# Product Change Notification

**Change Notification #:** 115549 - 00  
**Change Title:** Intel® NUC Kit, NUC6CAYH, PCN 115549-00, Label, Documentation, Product Material, Product Rating Label, Color Box Label and Attention/Regulatory Flyer Update for RED and Add Alternative Part For Manufacturability Support  
**Date of Publication:** May 30, 2017

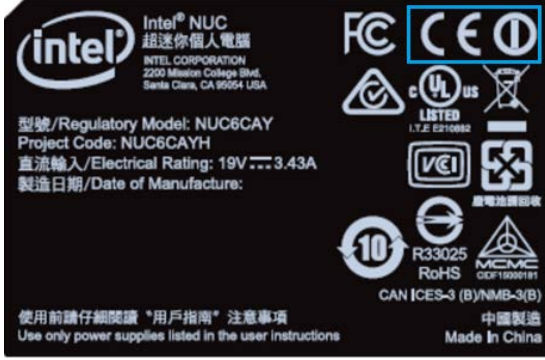
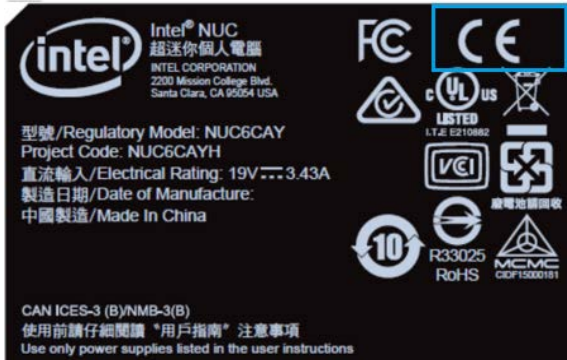
- Update Product Rating Label, Exterior Label on the Product Packaging Box and Collateral - Regulatory Flyer to support the new Countries Radio Equipment Directive (RED) and BSMI Regulatory Requirement.
- Add Alternative Wireless Module for manufacturability support purposes.
